# DESIGN SCENE

OFFICE OF PROJECT MANAGEMENT & TECHNICAL SUPPORT

April 2019 - Page 1

PROJECT DESIGN SERVICES UNIT

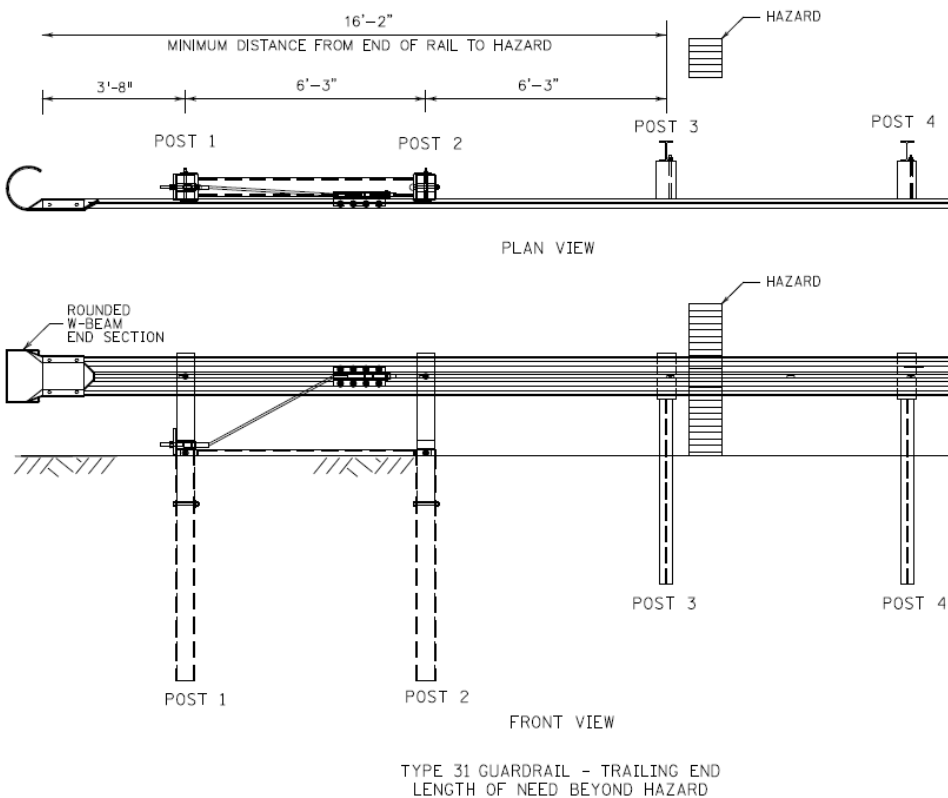
## **Chapter 14 – STIFFENED GUARDRAIL (Revised)**

*The last paragraph of this section is revised as follows to add clarification....*

*Ending Guardrail* - How far to take the guardrail beyond the hazard when shielding is not required in the opposite traffic direction? There is currently no statewide consensus on this. The guidance is different for 8338 vs. Type 31. For the interim we would recommend that 12’-6” be used as a minimum for type 8338, and that 16’-2” be used for Type 31 (12’-6” + 3’-8”).

This will take you to the end of the guardrail but not the rounded end of the anchorage as shown below...
